7-9 GIBBONS ST REDFERN – MAJOR PROJECT 08_0112
 RESPONSE TO SUBMISSIONS ARISING FROM PUBLIC EXHIBITION OF ENVIRONMENTAL ASSESSMENT

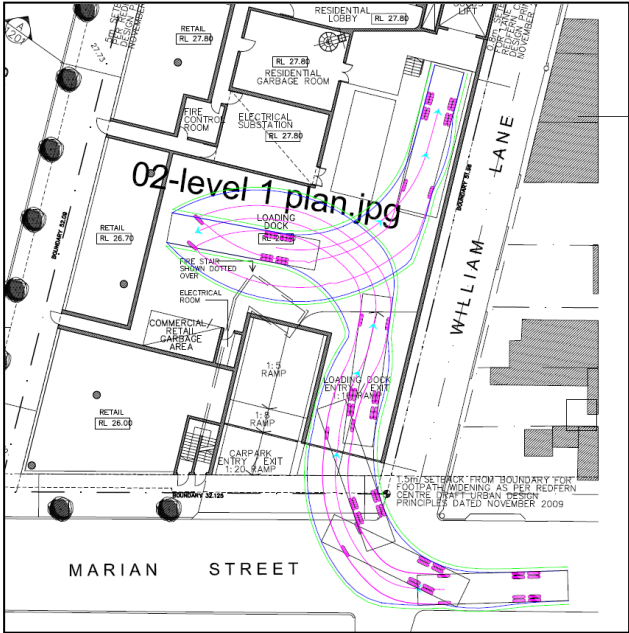
14.	<p>(City of Sydney) Design Issues</p> <p>The following design issues have been identified:</p> <ul style="list-style-type: none"> • The southern facade of the podium is a highly visible building element as viewed from Gibbons Street due to the low scale of the buildings to the south of the site which do not enjoy the increase in height that is attributed to the subject site under the Built Environment Plan and as

<p>such the subject building will remain visible in the future. It is noted that the majority of the southern facade of the podium is occupied by precast concrete with no visual relief. It is suggested that further design refinement of this element is necessary to provide an improved and satisfactory address to Gibbons and Marion Streets.</p> <ul style="list-style-type: none"> • The proposed access to the residential lobby is through the commercial lobby area. The commercial lobby area will be used by shoppers with their trolleys as well as commercial clients and it is completely inappropriate for residential occupants to have to negotiate the commercial lobby to access the residential lobby. Completely independent access should be provided for the residential occupants. • The 15m width of the driveway servicing the car park entrance and the loading dock is excessive and Council generally does not support a width greater than a double driveway due to the potential conflict between pedestrians and vehicles. At a minimum a pedestrian refuge should be provided to minimise conflict. • The proposed awning appears to extend over the carriageway of Gibbons Street in the south elevation. 	<p>Facade designs amended and are found in Attachment A.</p> <p>Separate lobbies have been provided</p> <p>The width of vehicular access has been minimised. A central refuge is considered inappropriate in this instance as it will necessitate the reduction of active retail uses in Marian St.</p> <p>The awning does not extend over the carriageway even though the drawing appears to show it. This is a consequence of the building being at an angle to the drawing of the elevation.</p>
